Community Solar Project Interconnection  
**Community Solar Project System Impact Study Report**

**(“Applicant”)**  
**OCS066**

Proposed Point of Interconnection  
**Circuit 5U84 out of Glide substation at 12.0 kV**  
**(At approximately 43.245551°N, 123.115325°W)**

**August 5, 2021**

Figure 1: System One Line Diagram

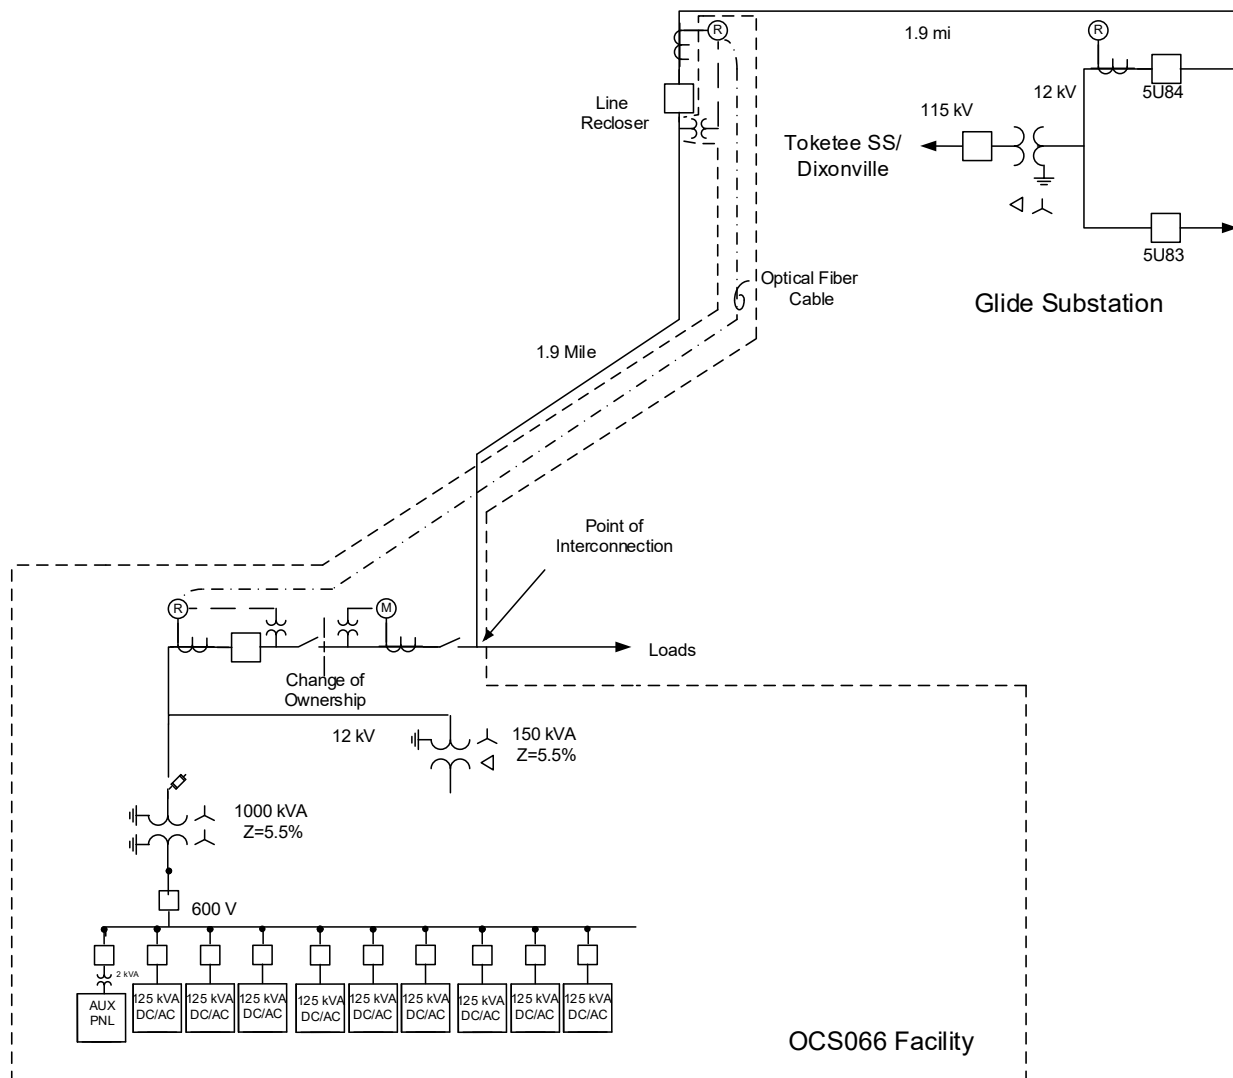
The Applicant will be required to install a transformer that will hold the phase to neutral voltages within limits when the Community Solar Project is isolated with the Public Utility's local system until the generation disconnects. The proposed grounding transformer will not accomplish the stabilization of the phase to neutral voltages on the 12 kV system. The circuit

that the project is connecting to is a four wire multi-grounded circuit with line to neutral connected load. Figure 1 shows the addition of a wye – delta grounding transformer of adequate power size and impedance that will meet the requirement. The grounding transformer will need to be a 150 kVA transformer with 5.5 % impedance.
